Review of City Planning's Proposed Land Use Parameters with Recommended Changes

VNC's Venice Community Plan and
Local Coastal Program Ad Hoc Committee

Oakwood Subarea Review

OAKWOOD – Residential Land Uses

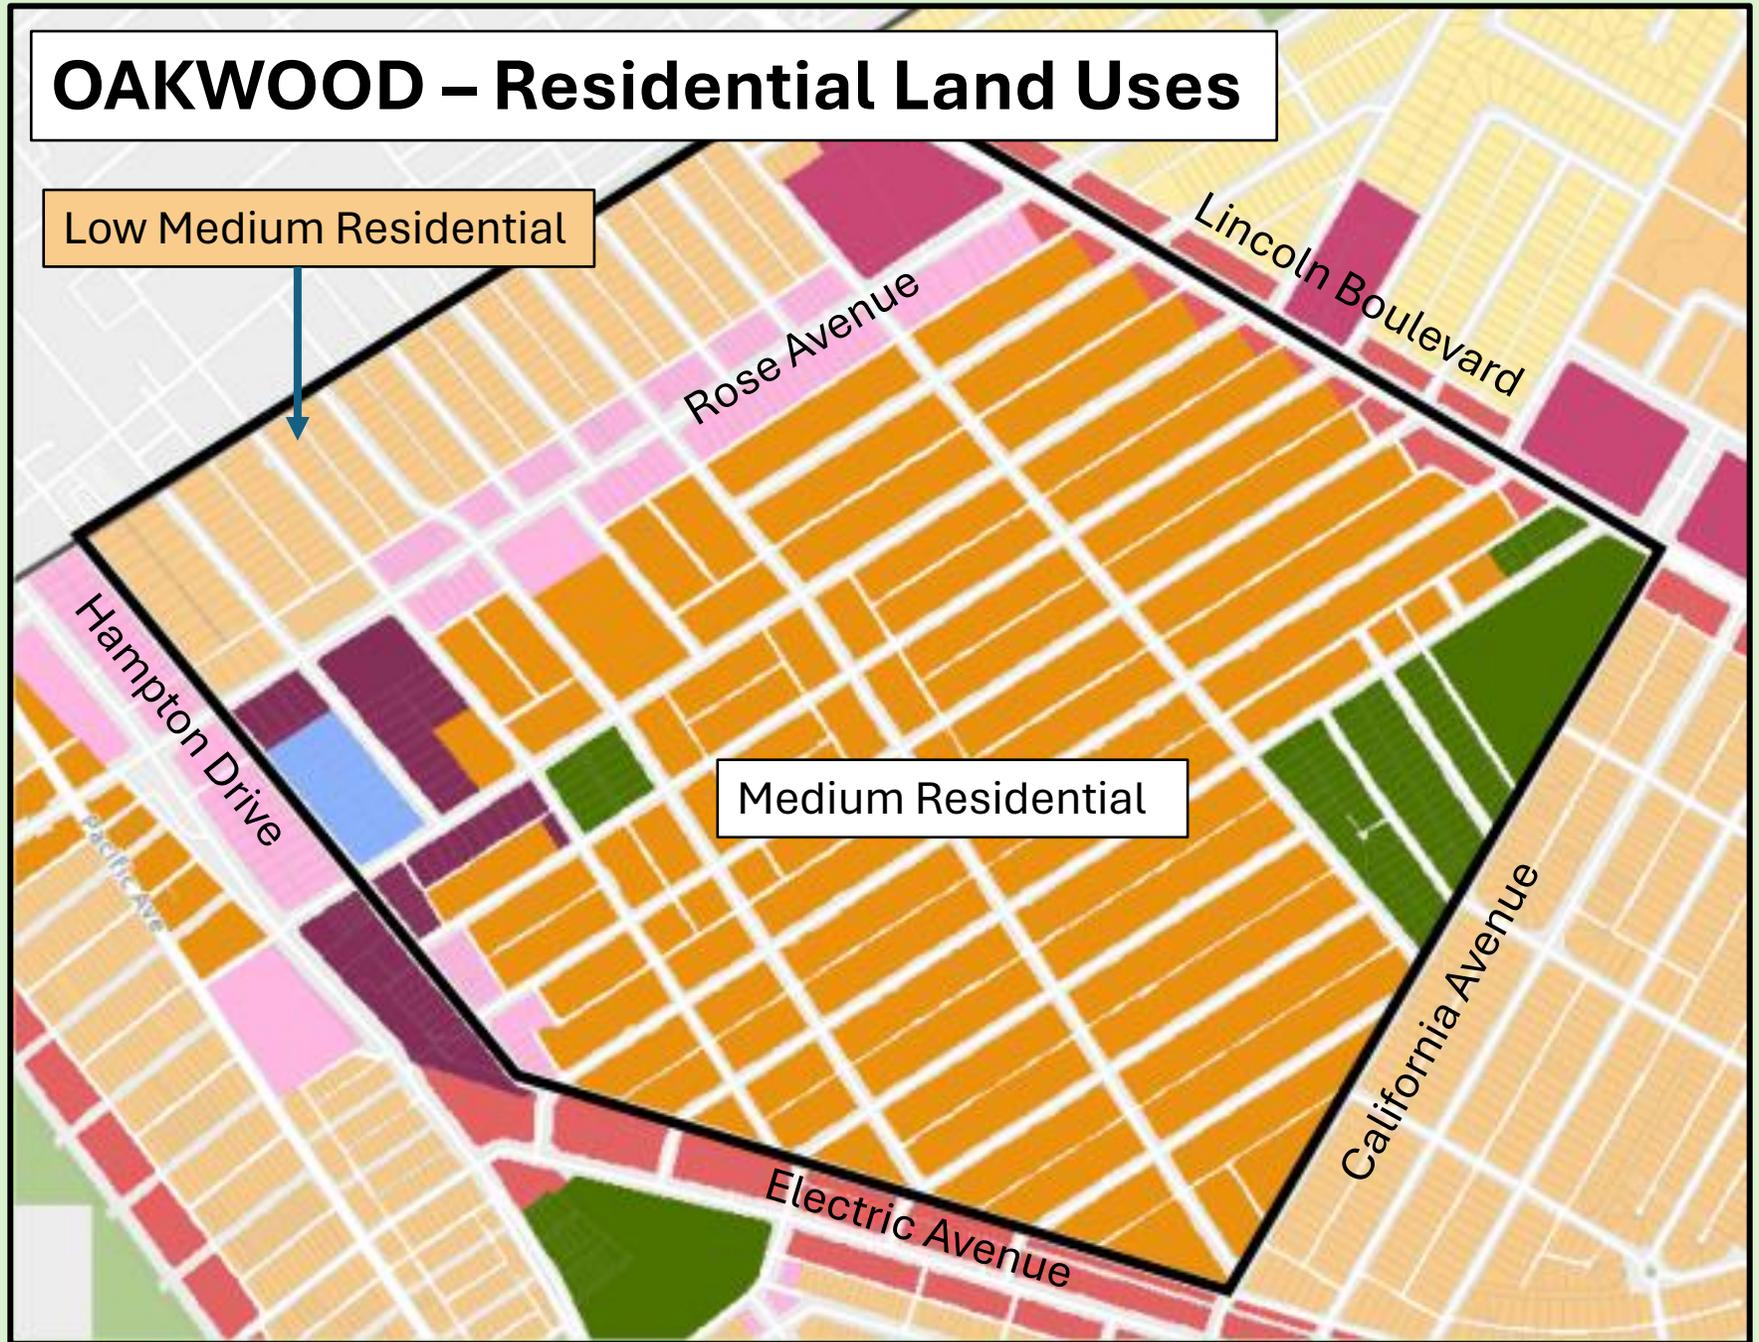
Proposed Changes from Existing Designation

Previously for lots zoned RD1.5 (yellow):
Density: 2 DUs if lot \leq 4,000 SF, +1 DU/1,200 SF
Example: 5,200 SF lot = **3 DUs** (plus bonuses)

Proposed City Planning for same lots (orange)
Density: 1 DU/800 SF of lot
Example: 5,200 SF lot = **6 DUs** (plus bonuses)

Residential Land Uses - Proposed, Existing, and Recommended Changes

Subarea	Oakwood	
Factor Residential Type	Low Medium Residential (north of Rose Avenue)	Medium Residential Change back to Low Medium Residential
Zoning	RD2-1	RD1.5-1
Density - DU/Lot (excluding ADUs)	1 DU/1,500 SF of lot 2 DU ≤ 4,000 SF 1 DU/2,000 SF above 4,000 Stay with existing	1 DU/800 SF of lot 2 DU ≤ 4,000 SF of lot 1 DU/1,500 SF above 4,000 Stay with existing
Maximum Height:	3 Stories (no bonus) 25' flat roof/30' sloped 2 Stories 25' flat roof/30' sloped	3 Stories (no bonus) 25' flat roof/30' sloped 2 Stories 25' flat roof/30' sloped
Floor Area Ratio (FAR):	1 (1.5) None 0.55 for SFR (no bonus) 0.75 (1.0) for MFR	1 (1.5) None 0.55 for SFR (no bonus) 0.75 (1.25) for MFR
Lot Coverage:	40%	40%
Lot Consolidation:	3 2 only for MFR project	3 2 only for MFR project

OAKWOOD – Commercial (Mixed-Use) Land Uses

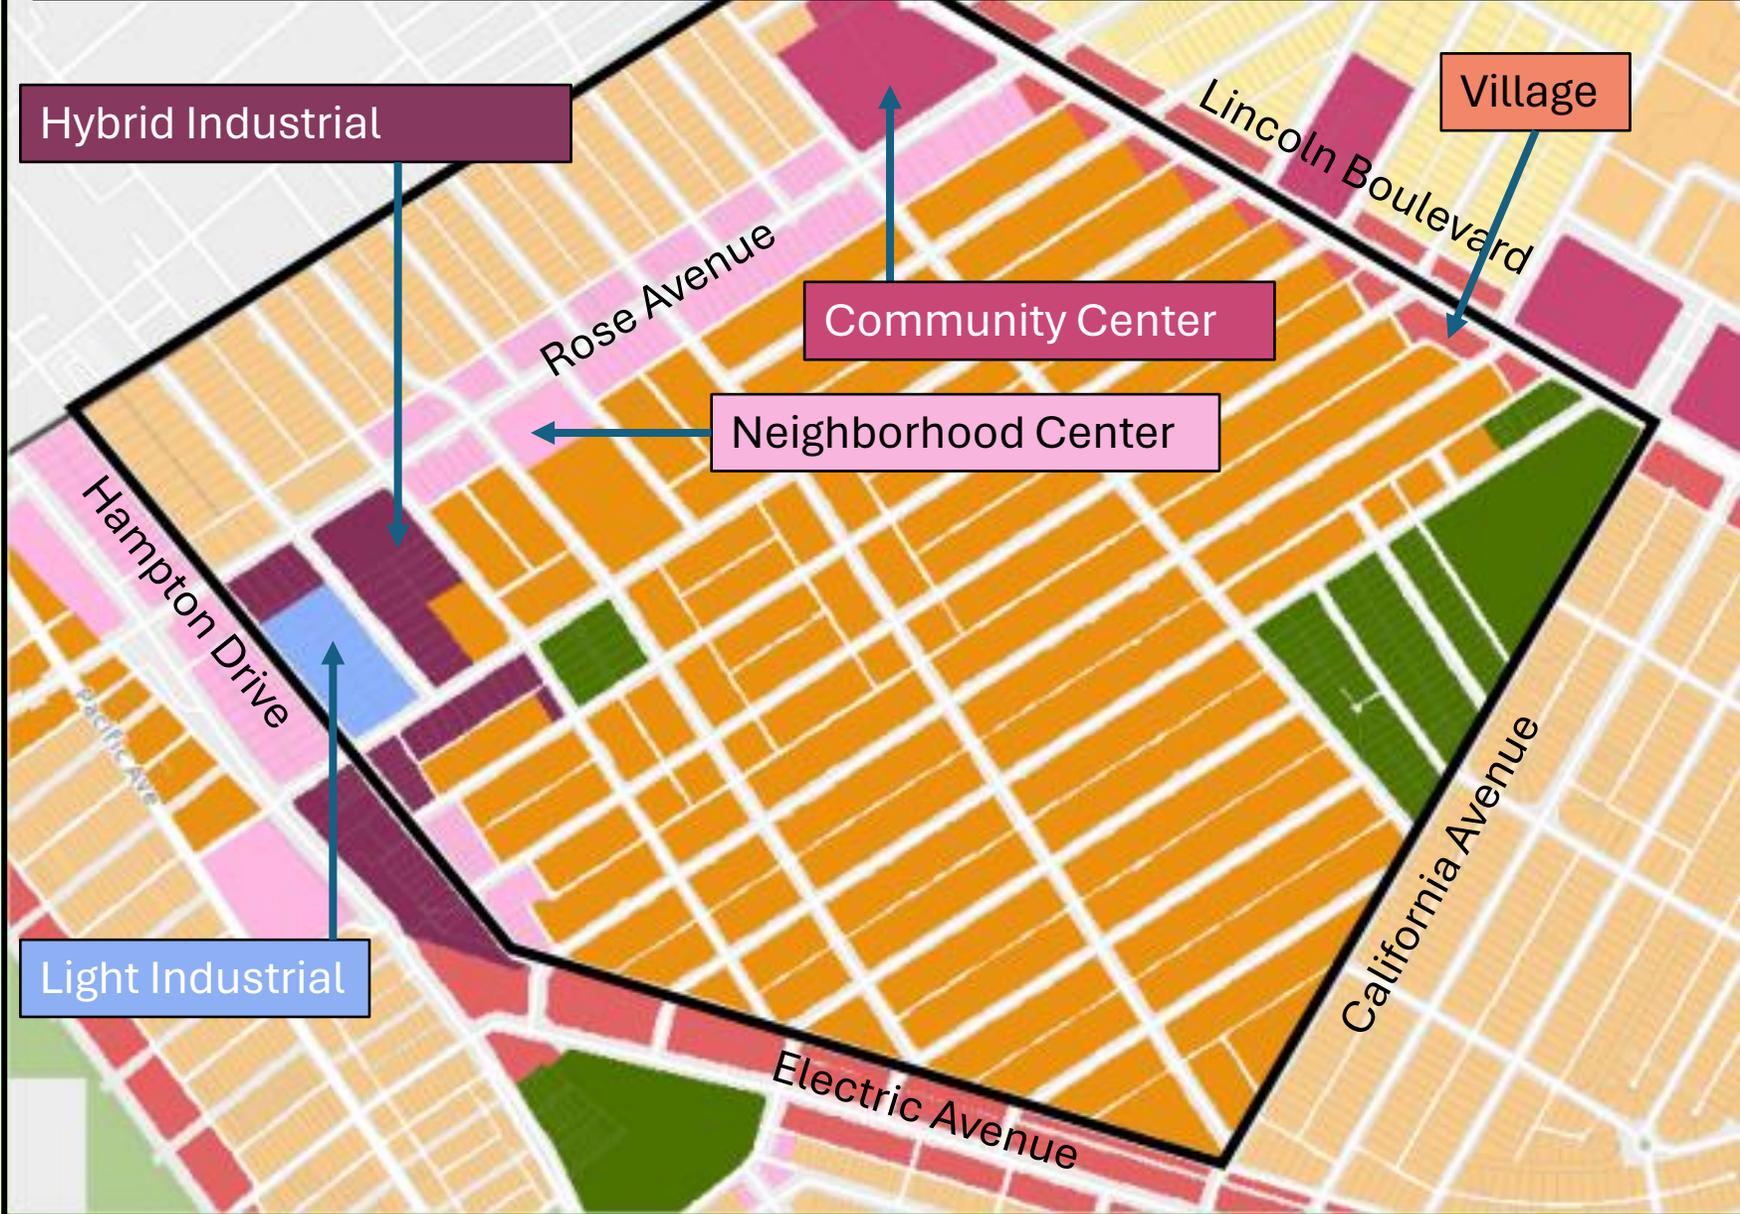
Commercial Land Uses - Proposed, Existing, and Recommended Changes

Subarea	Oakwood				
Factor Commercial Type	Neighborhood Cntr. (along Rose Avenue)	Villages (along Lincoln Blvd.)	Community Center (Lincoln north of Rose)	Hybrid Industrial (SW of 4th & Rose)	Light Industrial (Hampton at Sunset)
Zoning	C4-1, R3-1, M1-1	[Q]C2-1-CDO	[Q]C2-1-CDO	CM-1, [T][Q]CM-1, M1-1	M1-1
Density - SF/LU	800SF/LU None	400SF/LU None	400SF/LU None 800 SF/LU	800 SF/LU None	LUs not allowed None
Maximum Height:	3 Stories (5 Stories) 25' flat/30' sloped 3 Stories, 33' (4 Stories, 44')	3 Stories (5 Stories) 25' flat/30' sloped 3 Stories, ≤33' (5 Stories, ≤55')	3 Stories (8 Stories) 25' flat/30' sloped 3 Stories, ≤33' (5 Stories, ≤55')	3 Stories (5 Stories) No limit 3 Stories, ≤33' (4 Stories, ≤45')	3 Stories (5 Stories) No Limit 3 Stories (no bonus)
Floor Area Ratio (FAR):	1.5 (3) 1.25 (1.5)	1.5 (3) 1.25 (2.0)	1.5 (5) 1.25 (2.0)	1.5 (3) 1.25 (2.0)	1.5 (3) 1.25 (2.0)
Lot Coverage:	60%	60%	60%	60%	65%

Lot Consolidation:	2	3	2	2	2
